08V-483
(6 pages)

Subject: Recall Program Sunlite LQ Trailers

Subj: Sunlite Living Quarter Trailer Recall

Attachment: Remedy Instructions & Picture of Fuse Installation

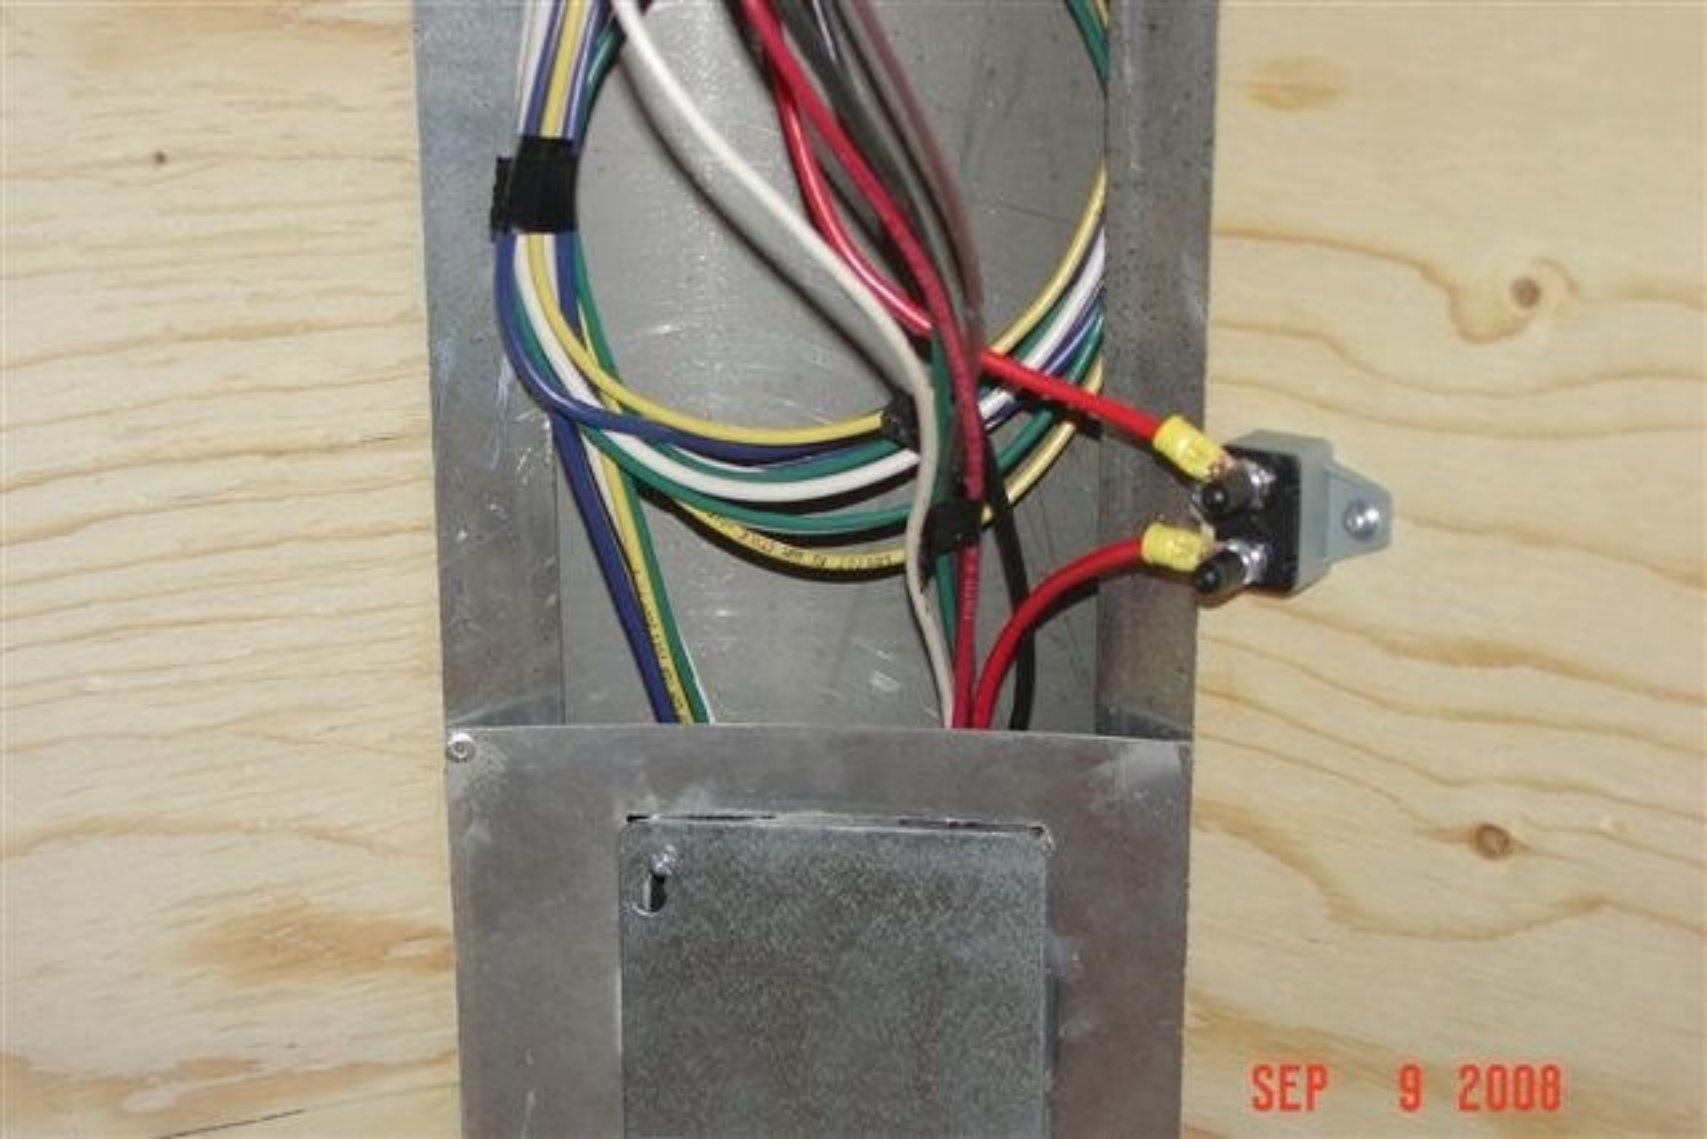
The individual trailers we are concerned with are not equipped with a fuse in line with the wire harness that connects to the tow vehicle. We have determined that if an improperly wired tow vehicle is connected to the trailer wiring harness there is a possibility of electrical short which could cause a fire resulting in property damage or injury to you and/or your stock.
